MS-1582 E

REQ.	ITEM	PART NO.	DESCRIPTION	SYMBOL					
		.064	THE TECHNICAL MATERIEL CORP. MAMARONECK, NEW YORK BRACKET, CONDENSER (CBI)						
		STOCK SIZE							
		ALUMINUM							
		MATERIAL							
ISSUE		ITEM	CHANGED FROM	DATE	CH. NO.	DRAFTS	CHECKER	ENG. APP.	
TOLERANCES				SCALE:					
DEC. DIM. ±				MAXIMUM ALLOWABLE TOLERANCES HAVE BEEN DETERMINED AND ANY DEVIATIONS WILL BE CAUSE FOR REJECTION: REMOVE ALL BURRS AND SHARP EDGES					
FRAC. DIM. ± 1/64									
ANGULAR DIM. ±									
		5052-H32	J.C. BIELE						
		TYPE & TEMPER	HEAT TREAT. SPEC.	DRAWN	CHECKED	FINAL APPROVAL			
		S-404 IRIDITE				MS-1582 E			
		FINISH & SPEC. NO.	ELEC. DES. APP.	MECH. DES. APP.

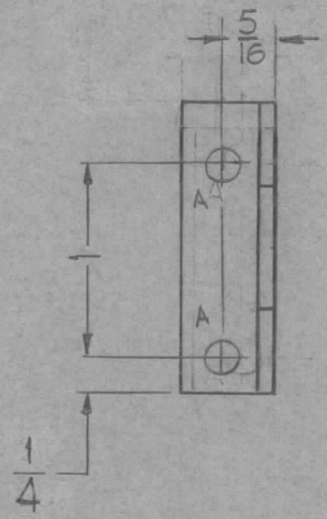
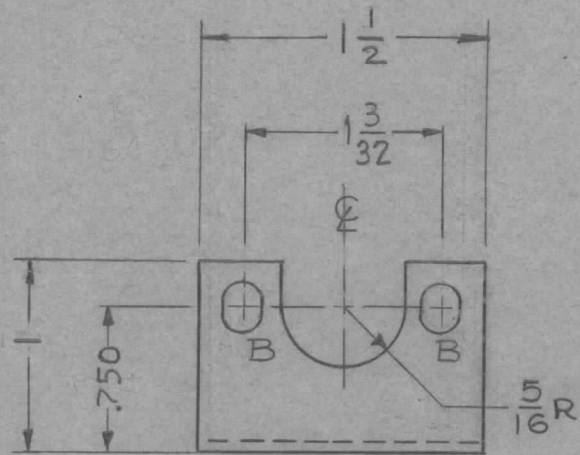
E		DELE. "5/16 REF."; 1/4 WAS 3/16	5-2-66	16185	HLA	CPZ	
D	1	"B"-SLOT WAS 3/16 x 1/4	1.21.65	13326	hpb	@	CPZ
C	1	5/16 DIM PROP. LOATED	9-11-63	9926	shy	guy	CPZ
B	1	5/16 REF DIM ADDED	3-28-63	8674	CPZ	guy	CPZ
A	2	(2) "B" SLOTS ADDED	7-27-60	2664	CPZ	guy	CPZ
A	1	(2) "A" HOLES DELETED
